RE: **ADDENDUM No. 1** to the Bidding Documents for
Project #25003, Intersection Improvements At CR 22/Orpha Dr And CR 37
Middlebury, Elkhart County

This **Addendum No. 1** consists of twenty-two (22) pages.

Elkhart County Highway Department
Project #25003, Intersection Improvements At CR 22/Orpha Dr And CR 37
Middlebury, Elkhart County

MIDDLEBURY
MIDDLEBURY INTERSECTION IMPROVEMENTS
PLAN & PROFILE - LINE "PR-B"
STA. 273+00 TO STA. 279+00

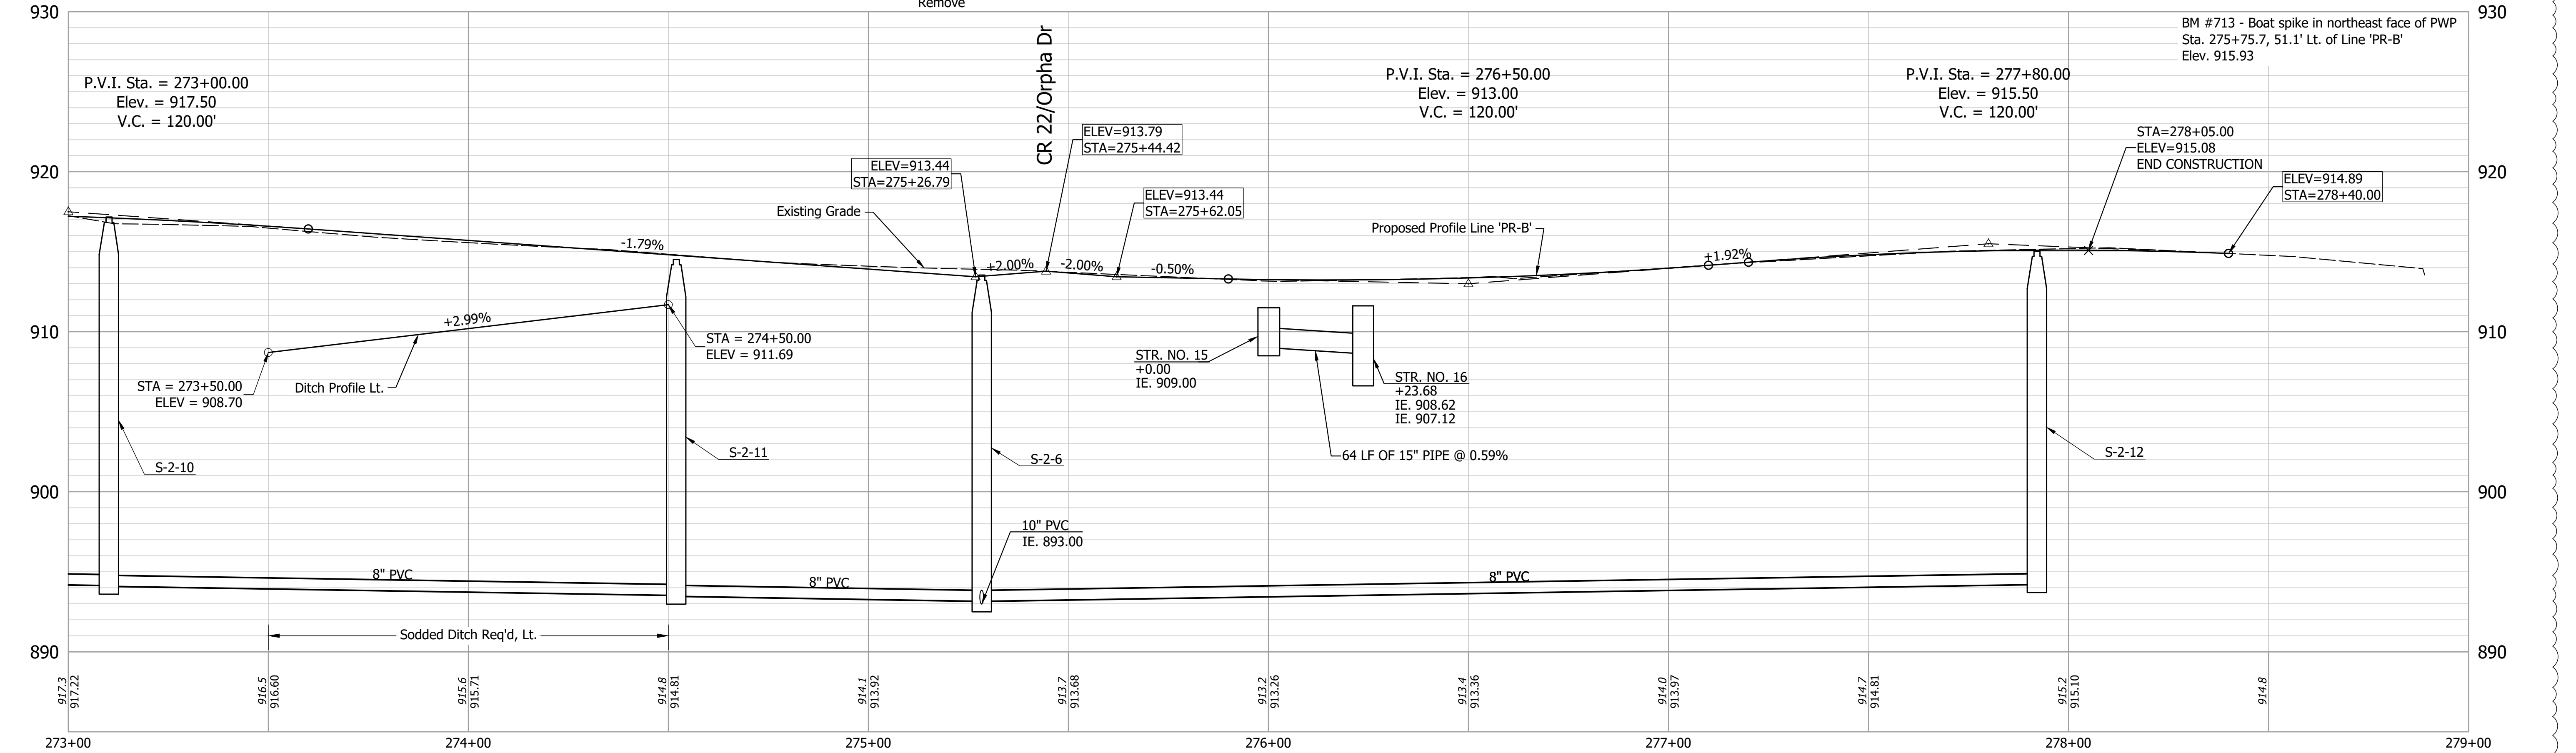
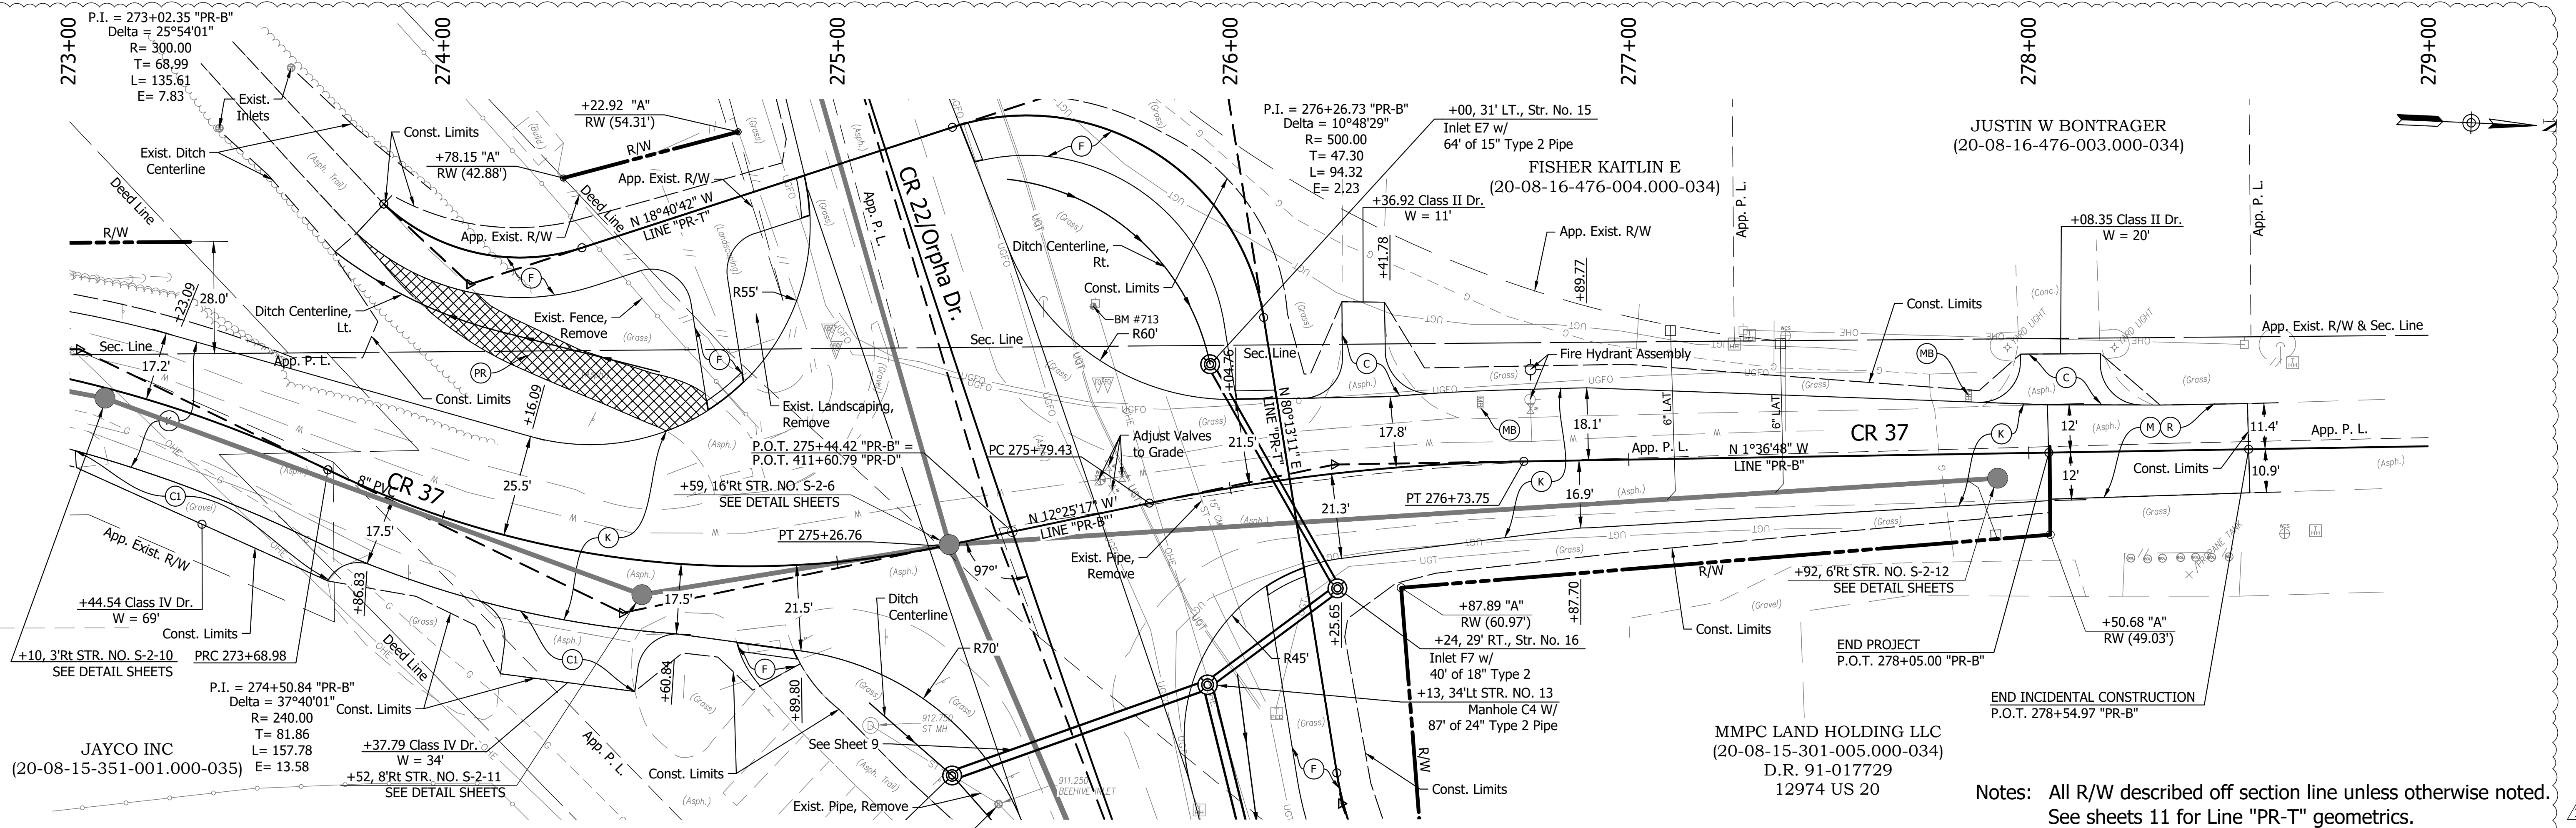
Sheets 6 -11 – Updates to the sanitary sewer

DRAWN: DJG	CHK'D: BJS	NO.	REVISION	DATE
DESIGNED: EH	APPR'D: BSS	1	SANITARY SEWER UPDATES	10/2/26
DATE: 06/25/2025		2		
HORIZ. SCALE: 1" = 20'		3		
VERT. SCALE: 1" = 5'		4		
PROJECT NUMBER		5		
25003		6

TOWN OF MIDDLEBURY, INDIANA
INTERSECTION IMPROVEMENTS
AT CR 22 / ORPHA DR AND CR 37
MIDDLEBURY, IN
SANITARY SEWER PLAN AND PROFILE
COUNTY ROAD 37

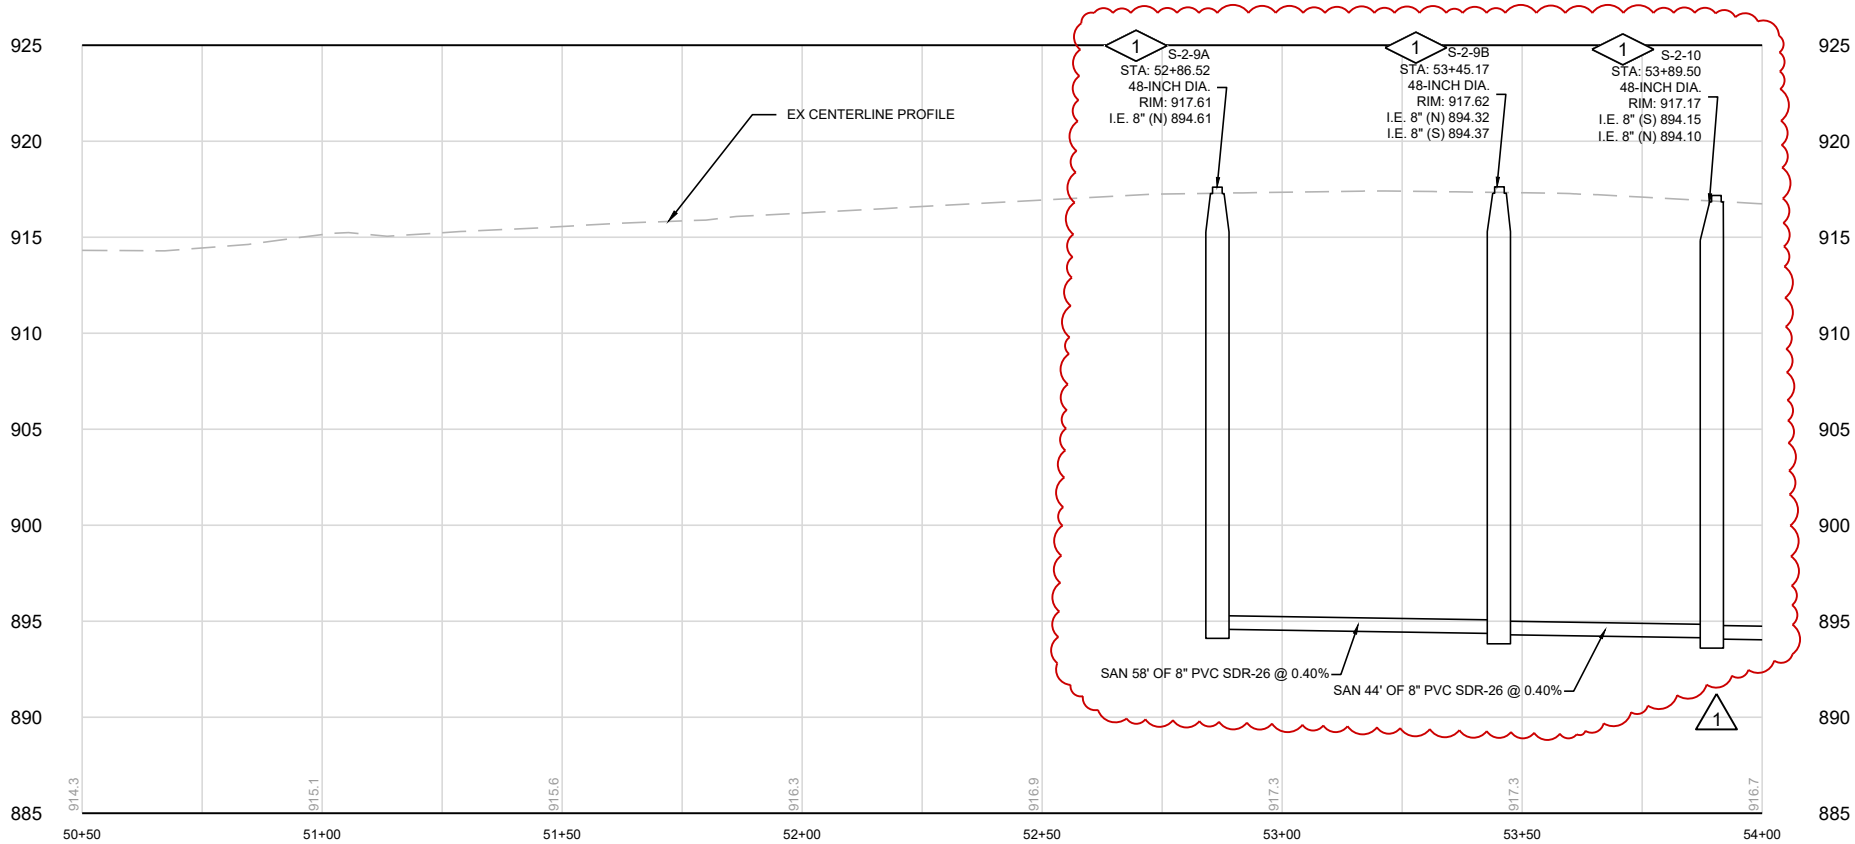
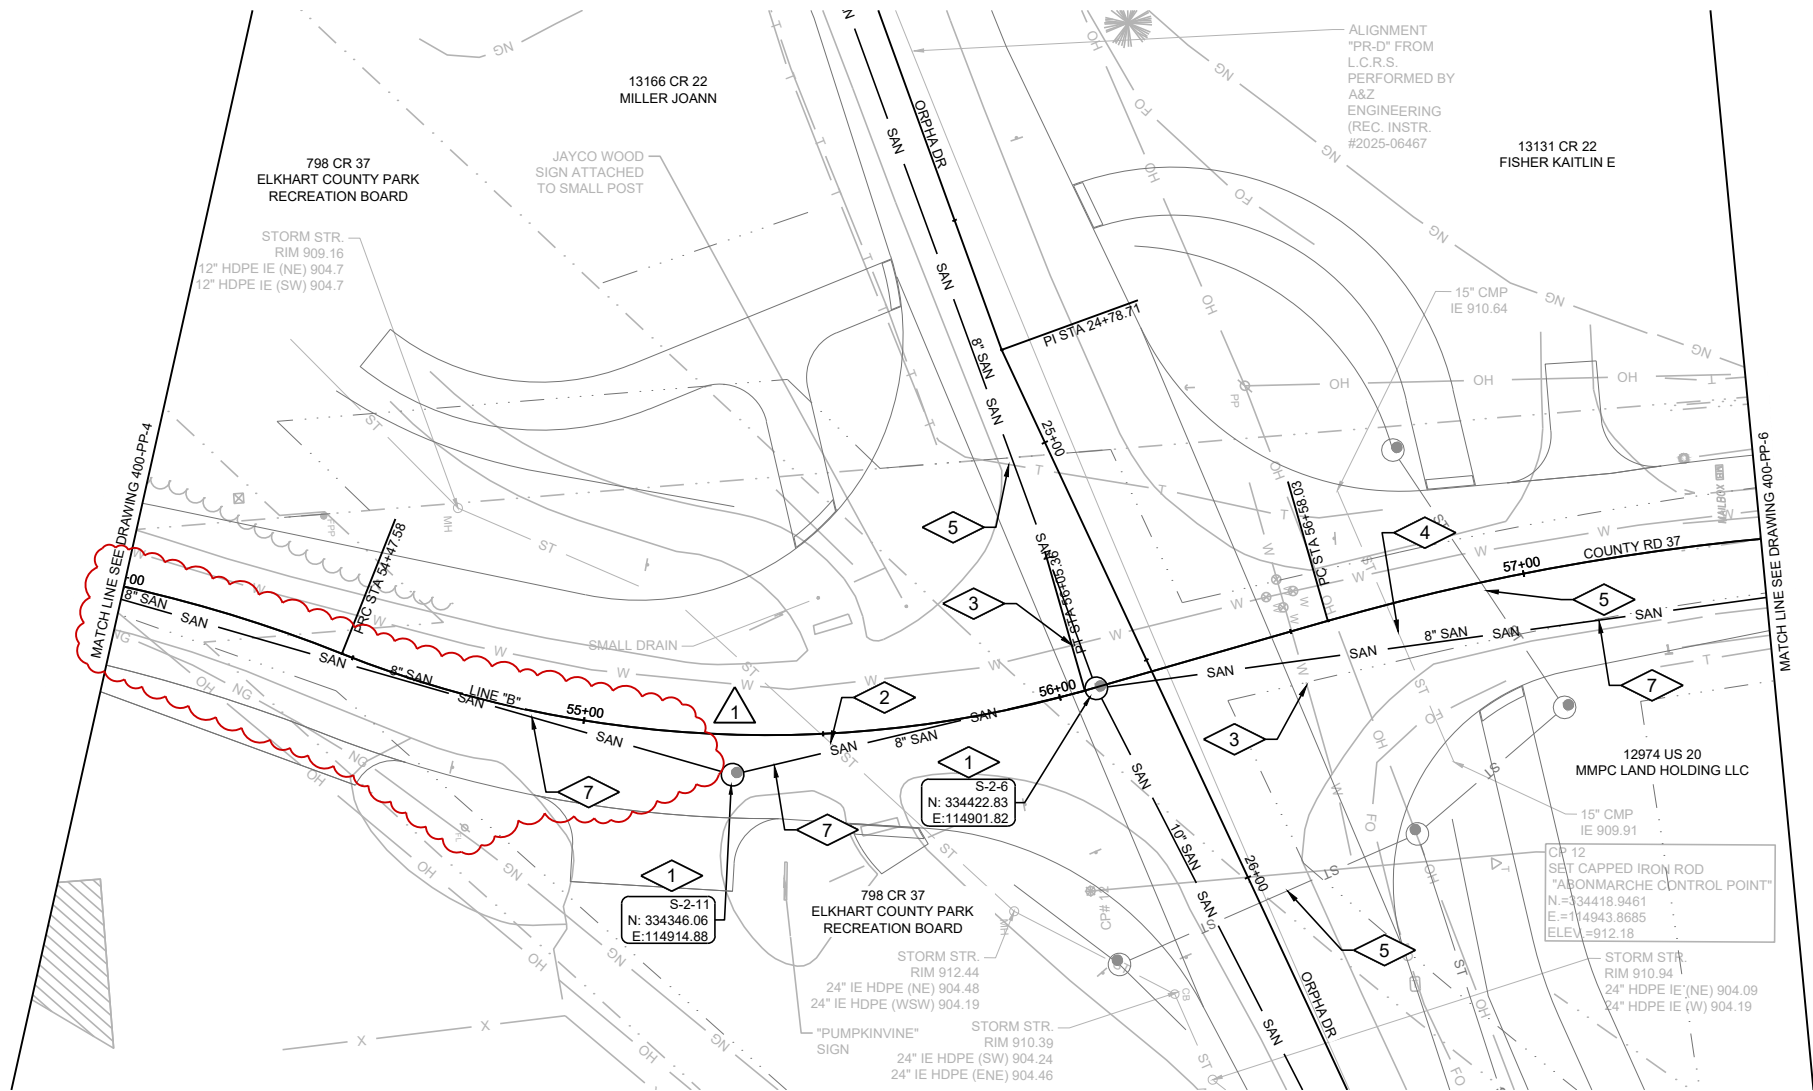
Sheets 12, 15-17 - Revised sanitary sewer alignment to avoid the gas, and addition of the lateral riser elevation information (see profile).

Q: The sanitary was identified to be in conflict, or in close proximity, to the gas main on the south end of the project.

A: Lochmueller will consult with Donahue regarding shifting the sanitary alignment.

TOWN OF MIDDLEBURY, INDIANA
INTERSECTION IMPROVEMENTS
AT CR 22 / ORPHA DR AND CR 37
MIDDLEBURY, IN
SANITARY SEWER PLAN AND PROFILE
COUNTY ROAD 37

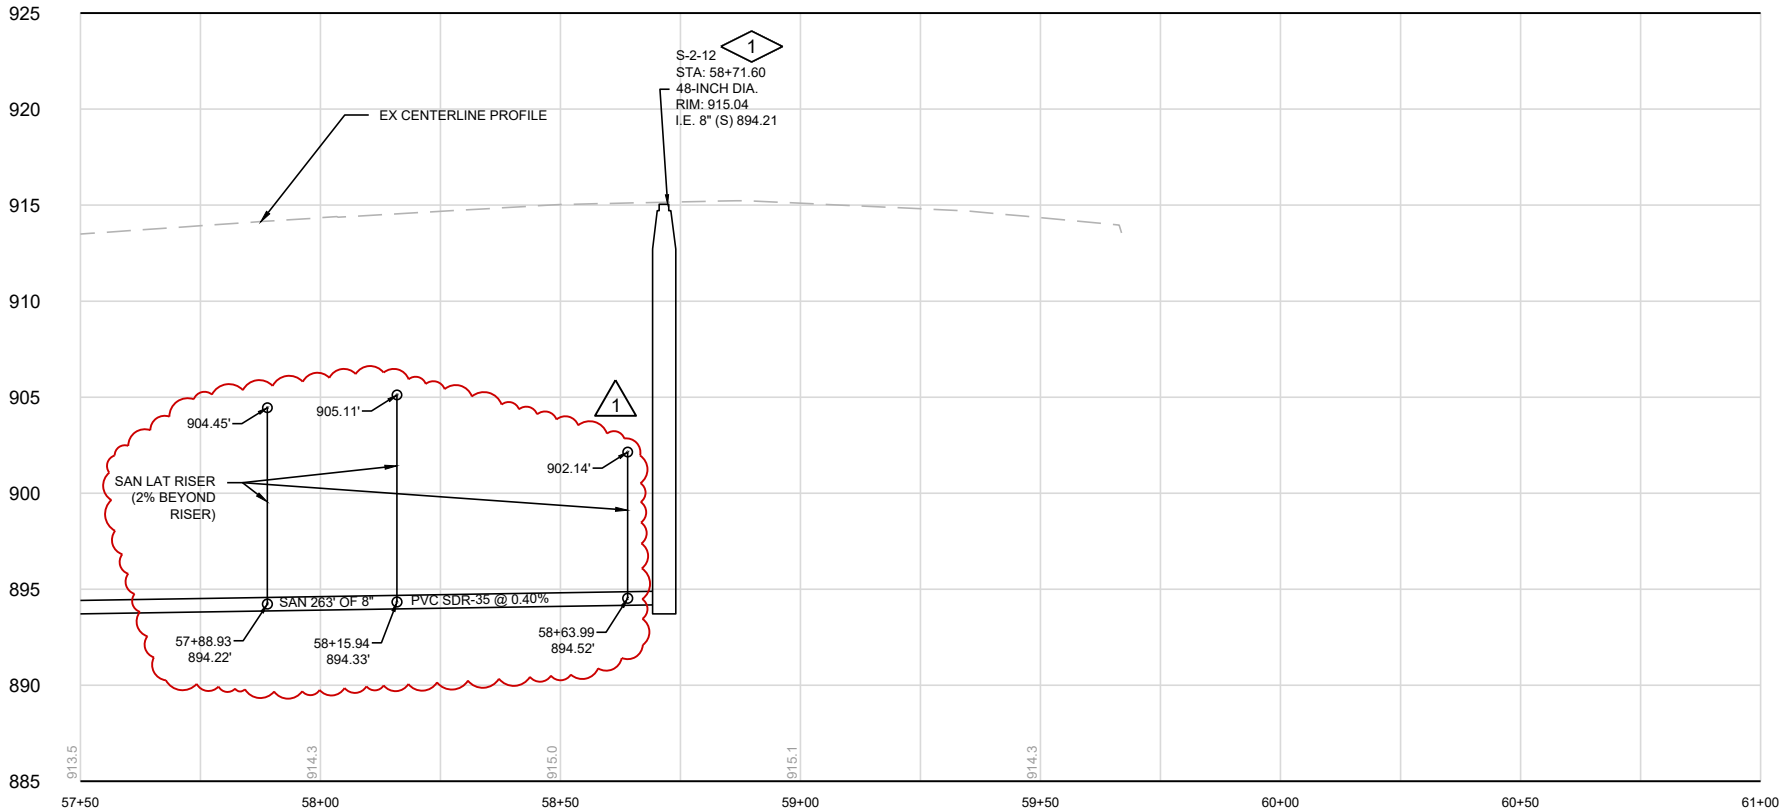
Q: What are the sanitary lateral depths?

1. NEW SANITARY MANHOLE. SEE TOWN OF MIDDLEBURY DETAILS, FIGURES 3.4 AND 3.5.
2. NEW SANITARY SEWER LATERAL. PROVIDE WYE CONNECTION, 45 DEGREE BEND, CLEANOUT, CONCRETE COLLAR, TRACER WIRE, ACCESS POINT AND MAGNESIUM GROUND ROD. CAP AT END OF LATERAL FOR FUTURE CONNECTION. SEE TOWN OF MIDDLEBURY STANDARD DETAILS, FIGURE 3.2.
3. NEW SANITARY SEWER.
